Hero Granger-Taylor's comments on the document

'Heritage Agreement Method Statement (HAMS - monitoring and conservation management of ground movement due to below ground construction at 22 Park Village East - ADP-ESCT-02', SCS Railways document number 1MCo<sub>3</sub>-SCJ-EV-MST-SSo<sub>1</sub>\_SLo<sub>3</sub>-oooo<sub>15</sub>.

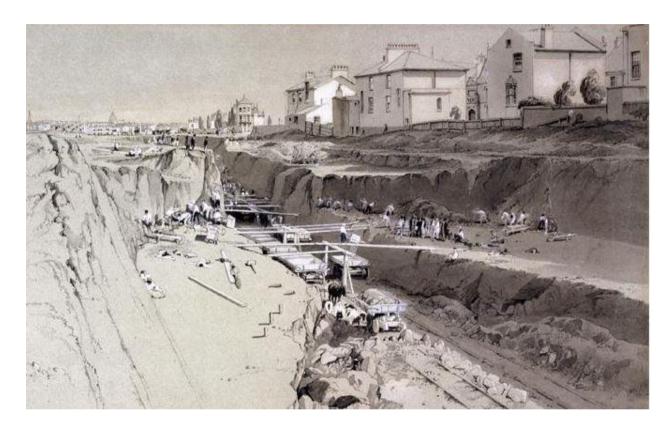
One senses an attempt at 'divide and rule' here, as with the failure to alert HG-T's neighbours at 24 PVE of the present application, but on a larger scale. And it certainly suits the document's evident purpose, to downplay the historic importance of the PVE houses while at the same time presenting 22 PVE as more damaged and more altered than it actually is.
